## Service Information Letter

### **Subject:**

Shimmy Damper Mounting Bracket

Model 208 and 208B with STC10841SC conversion applied.

Figure 1 Shimmy Damper Mount Bracket Assembly

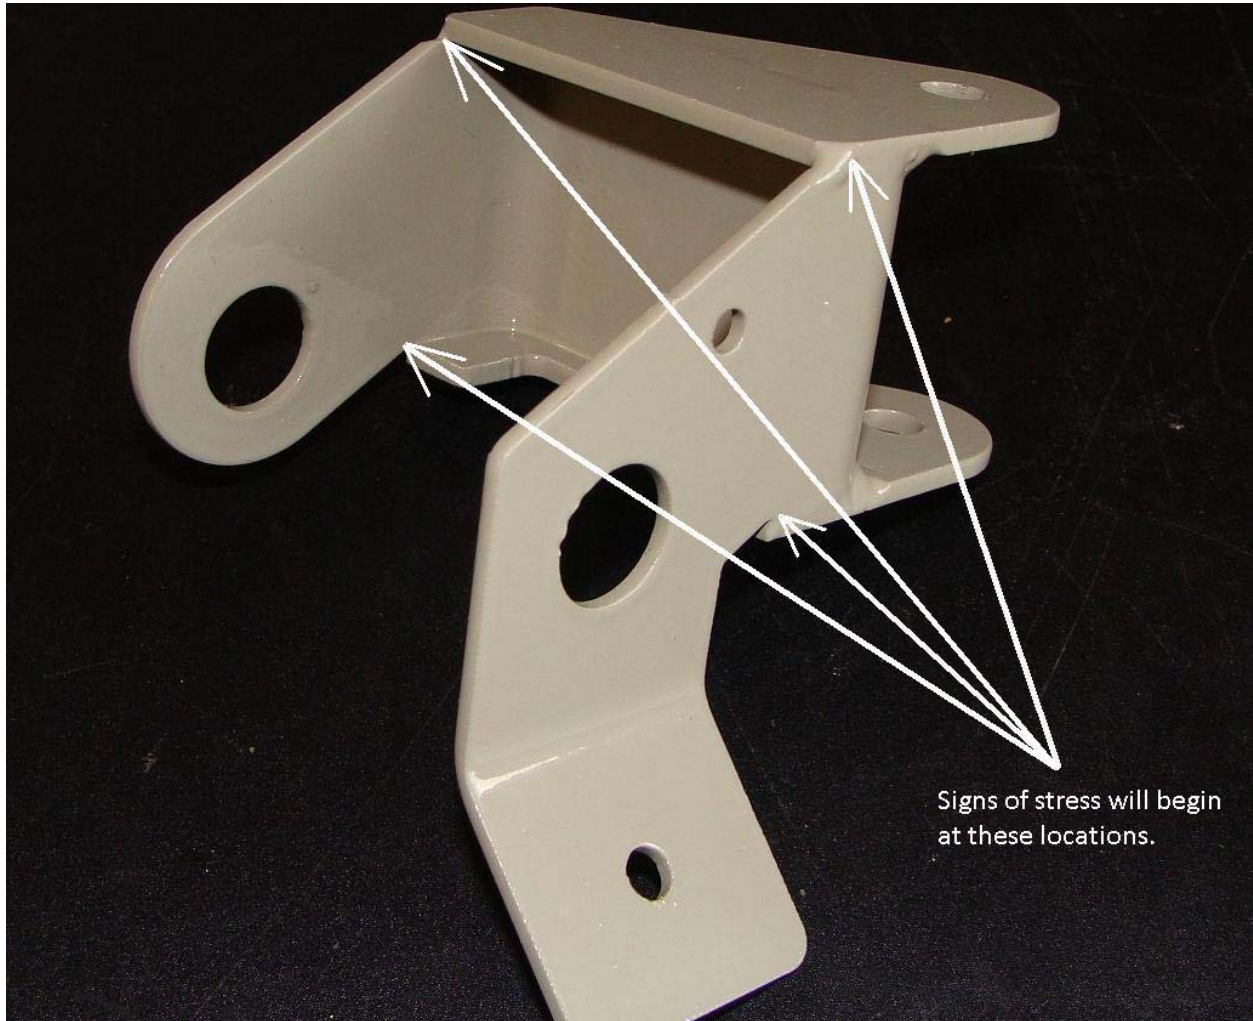
The purpose of this Service Information Letter (SIL) is to inform operators and maintenance technicians of a potential failure in the shimmy damper mounting bracket assembly. Figure 1 shows the stress concentration locations that should be inspected prior to each flight. The new design is in the process of being approved and notification of availability will be made per Service Bulletin No. SB-208-1. Regular preflight inspections of the shimmy damper mounting bracket assembly are essential towards preventing a possible failure.

Over the past 2 years, Supervan Systems Ltd. has noticed that the shimmy damper mounting bracket assembly has shown signs of fatigue. In response to this condition, Supervan Systems Ltd. has designed an improved shimmy damper mounting bracket assembly which will improve the durability of the design. The replacement of this shimmy damper mount bracket assembly will be mandatory.
